Service Bulletin

No. : MZ06-021

Model: ZR6001/ZR6001SP

Subject: Software Update

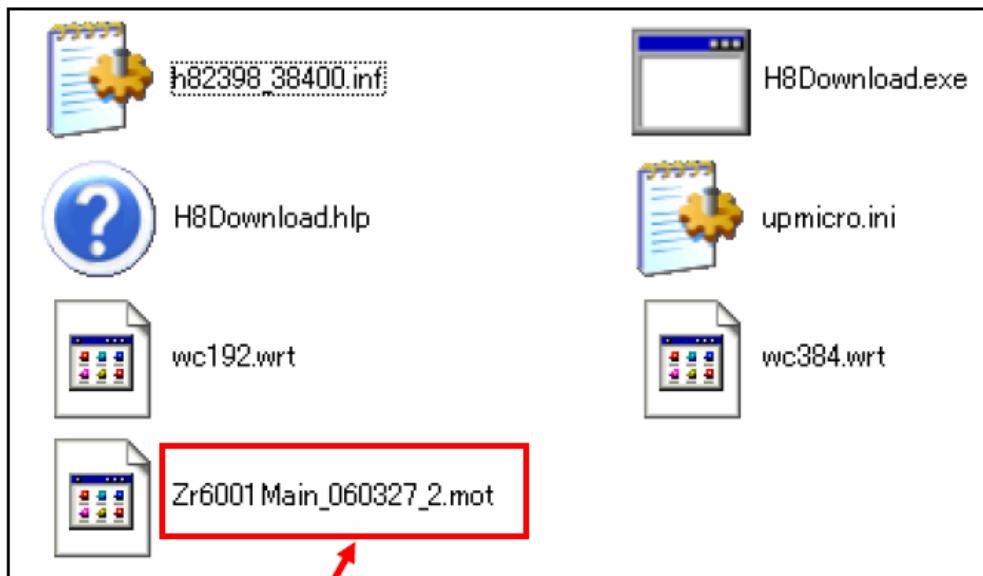
2. Press **MULTI** button, The software version of the MAIN microprocessor (IC28) is displayed in the format below.

V 0 6 0 3 0 6 I U | | |
ear Month Date Dest.
(Dest. : Destination) → **V060327 2**

Sub CPU Update Procedure:

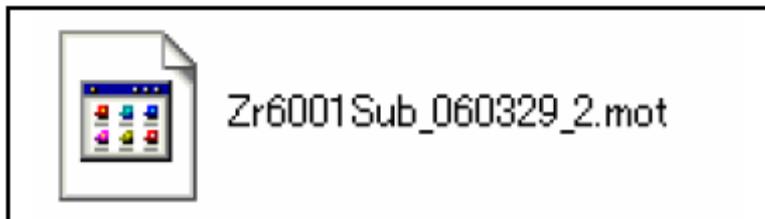
Unzip the firmware update file (Zr6001Sub_060329_2.zip) and double click to open.
